Office Action Summary

10/736,945

MARIA J. LAIOS

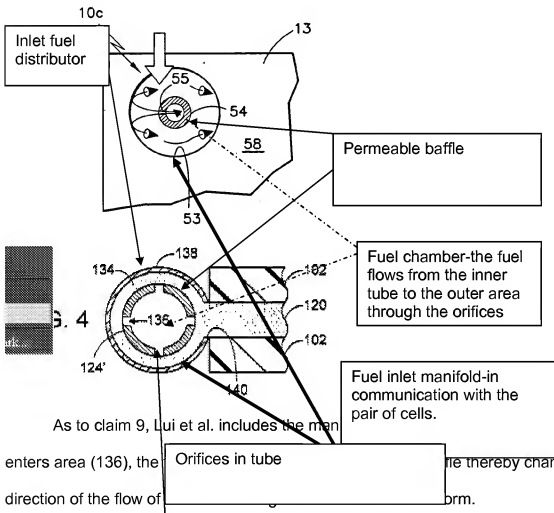
8. Claims 2, 4, 9 and 12 are rejected under 35 U.S.C. 102(e) as being anticipated by Lui et al. (US 2004/0058220 A1).

As to claims 2 and 4, Lui et al. discloses a fuel cell system comprising a pair of cells (Paragraph 26). Each of the cells will inherently have a fuel flow field and a fuel inlet and a fuel supply pipe. (See Figures below for a comparison match between applicants figure of the elected specie and Lui et al. figure)

As to claim 12, the fuel inlet distributor comprises a first internal manifold receiving fuel from the fuel supply pipe (area 136) a second internal fuel manifold (area

134) providing fuel to the fuel inlets and receiving fuel through the permeable baffle from the first internal fuel manifold (figure above).

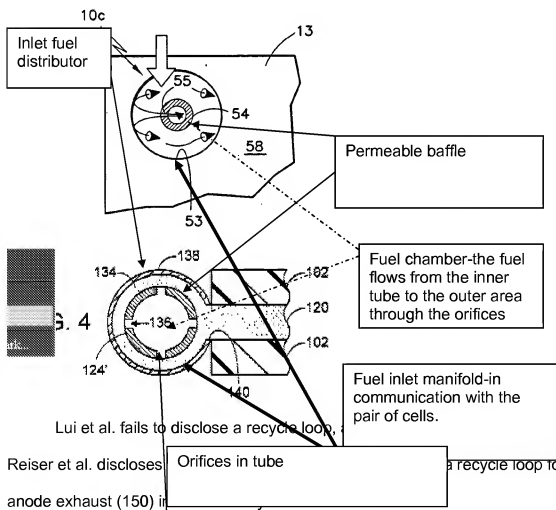
11. Claim 14 is rejected under 35 U.S.C. 103(a) as being unpatentable over Lui et al. (US 2004/0058220 A1 in view of Reiser et al. (US 2002/0076582 A1).

As to claim 14, Lui et al. disclose a plurality of fuel cells, each of the fuel cells have at least one fuel flow field and a fuel inlet and fuel outlet. Each of the cells will inherently have a fuel flow field and a fuel inlet and a fuel supply pipe. (See Figures below for a comparison match between applicants figure of the elected specie and Lui et al. figure)

However Lui modified by Reiser fail to disclose the recycled fuel is provided down stream of the permeable baffle.

It would have been obvious to one of ordinary skill in the art at the time of the invention to replenish the fuel in the system because it would save the fuel from being expended. Furthermore the placement of the fuel downstream of the baffle would allow the recycled fuel to enter the cells directly and would further mix with the fuel entering from the orifices thus homogenizing the fuel entering the cells.

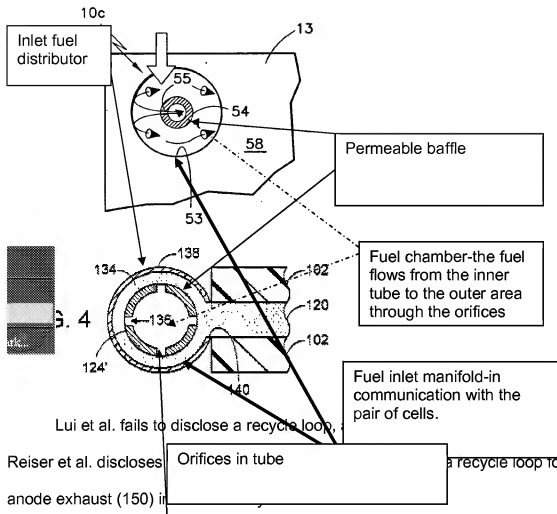
12. Claims 1 and 13 are rejected under 35 U.S.C. 103(a) as being unpatentable over Lui et al. (US 2004/0058220 A1 in view of Reiser et al. (US 2002/0076582 A1) and LaPierre et al. (US 6,348,278.

As to claim 1 and 13, Lui et al. disclose a plurality of fuel cells, each of the fuel cells have at least one fuel flow field and a fuel inlet and fuel outlet. Each of the cells will inherently have a fuel flow field and a fuel inlet and a fuel supply pipe. (See Figures below for a comparison match between applicants figure of the elected specie and Lui et al. figure)

Lui et al. fails to disclose a recycle loop.
 Reiser et al. discloses a recycle loop for the anode exhaust (150) in

However Lui modified by Reiser fail to disclose the recycled fuel is provided down stream of the permeable baffle.

It would have been obvious to one of ordinary skill in the art at the time of the invention to replenish the fuel in the system because it would save the fuel from being expended. Furthermore the placement of the fuel downstream of the baffle would allow the recycled fuel to enter the cells directly and would further mix with the fuel entering from the orifices thus homogenizing the fuel entering the cells.

Reiser further discloses a valve (170) which is in fluid communication with the cells and is upstream from the manifold inlet. Since the valve is downstream of the exiting gas it will be located a distance from the interconnection of the fuel inlet chamber and the supply pipe. It would have been obvious to one of ordinary skill in the art to include a valve in the recycle system in order to control the amount of fuel being recycled.

Lui et al. modified by Reiser fail to disclose a controller controlling the valve. LaPierre et al. disclose a controller (150) for controlling the valves during start up.

It would have been obvious to one of ordinary skill in the art at the time of the invention to include the controller of LaPierre et al. to the system of Lui modified by Reiser because the controller can adjust the valve to control the flow rate of the fuel (col. 17 lines 57- col. 18 line 5).
